SUBJECT: Contract No. DE-AC07-05ID14517 — Next Generation Nuclear Plant Project Submittal —  
Response to Nuclear Regulatory Commission Request for Additional Information Letter No.  
002 Regarding Next Generation Nuclear Plant Project Fuel Qualification and Mechanistic  
Source Terms — NRC Project # 0748

NGNP Response to NRC RAI Letter No.002

**Request for Additional Information No. 5772 Revision 0**

Figure 1. Description of the THTR NATE Sensor System

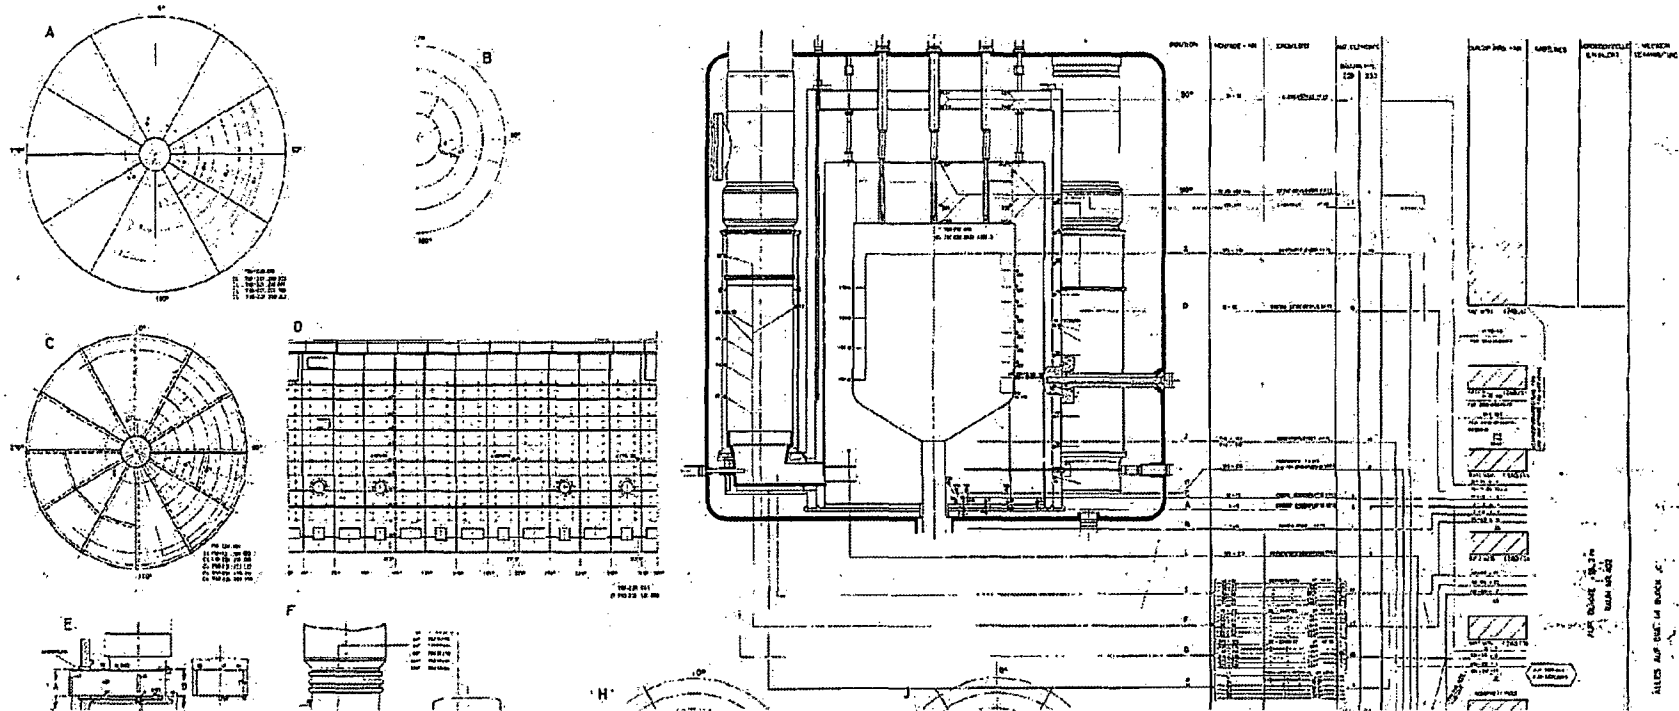
<sup>9</sup> Note: Please provide a reference that describes the THTR’s “NATE” sensor system and its use to monitor temperature profiles in the bottom reflector, as mentioned in [H. Kalinowski, July 2001].

Among the footnotes to the comments that accompany this RAI was a request that the NGNP Project provide a reference that describes the Thorium High Temperature Reactor (THTR) "NATE" sensor system and its use to monitor temperature profiles in the bottom reflector, as mentioned in [H. Kalinowski, July 2001]. Prior to receipt of this RAI, the NGNP Project had no information on the NATE sensor system. Upon further investigation, it was learned that [H. Kalinowski, July 2001] is a handout attached to an NRC trip report that is filed under the NRC's Agency wide Documents Access and Management System (ADAMS) under accession number ML092250104. The report is for a trip to Germany taken by NRC staff in 2001 to review various topics related to pebble bed HTGR safety. The reference cited is a handout for a presentation by Dr. Helga Kalinowski on startup testing at THTR. The handout includes a handwritten drawing that shows a plan view of the locations of the NATE sensors at the bottom of the reactor.

"NATE" is a German acronym for "Nicht-Autauschbare Thermo-Elemente", which in English translates approximately to "nonreplaceable temperature sensor element". These were hard-wired sensors that were located in THTR throughout the reflector (side and bottom) and at the inlet to the SG bundles. They were thermocouples that were designed as special commissioning instruments. Should they fail to function during the plant life, they would be left in place and would not be replaced since they were not needed for the operation of the plant. These sensors could be read into a computer at a press of a button to record the temperatures. This was done during the start up at 40, 60, 80 and 100% power.

Figure 1 is a page from the "THTR Shift Supervisor Training Manual – Metallic and Graphite Reactor Internals - Document Number CU0025". It includes a brief description of the NATE sensor system. The document is in German. Figure 2 is another drawing that shows the location of the THTR NATE sensors.

**Figure 1. Radionuclide Design Criteria**

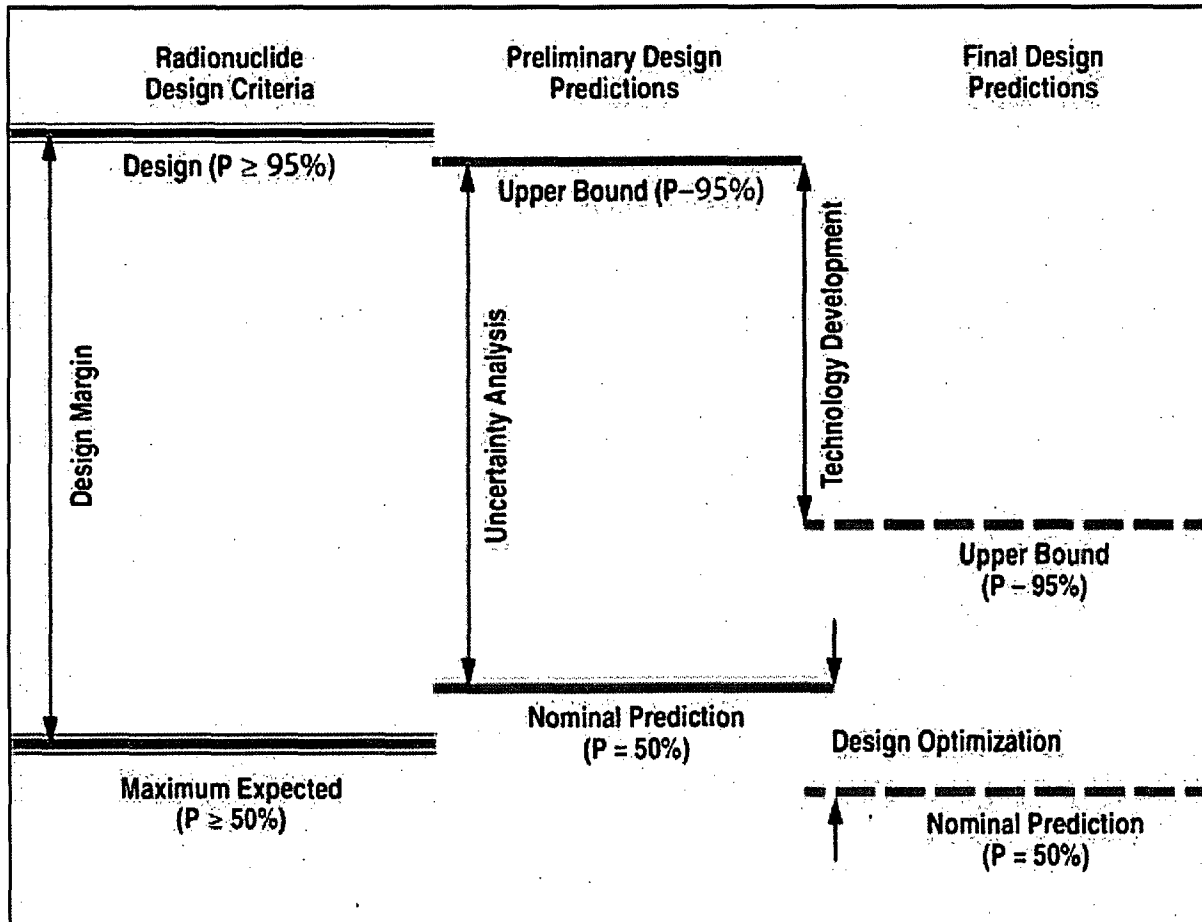
**RAI MST-87:** Please explain Figure 2-5 more clearly in terms of examples of how it would relate to a proposed mechanistic source term calculation.

Standard design practice in the U.S. HTGR program has been to define a two-tier set of radionuclide design criteria—referred to as Maximum Expected and Design criteria—for allowable core releases for normal operation and Anticipated Operational Occurrences (AOOs). This practice has been followed since the design of Peach Bottom Unit 1 and Fort St. Vrain up through the design of modular HTGRs. The Design criteria are derived from externally imposed requirements, such as site-boundary dose limits, occupational exposure limits, etc. Once the Design criteria have been derived from the radionuclide control requirements, the corresponding Maximum Expected, criteria are derived by dividing the Design criteria by an uncertainty factor, or design margin, to account for uncertainties in the design methods. This uncertainty factor is typically a factor of four for the release of fission gases from the core and a factor of 10 for the release of fission metals from the core (see response to RAI MST-62 for further discussion of these factors). The fuel and core are to be designed such that there is at least a 50% probability that the fission product release will be less than the Maximum Expected criteria and at least a 95% probability that the release will be less than the Design criteria. The GA approach to implementing such radionuclide design criteria is illustrated in Figure 1, which is a reproduction of Figure 2-5 from the

Mechanistic Source Terms White Paper provided for easy reference. No particular scale is implied in this figure; it is simply a conceptual illustration of the approach.

These radionuclide design criteria have multiple uses in plant design and licensing. First, they provide a figure of merit for judging the acceptability of candidate core designs. Secondly, they allow the plant design and safety analyses to proceed while the core and fuel designs are being optimized as the overall plant design evolves through the conceptual, preliminary, and final phases.
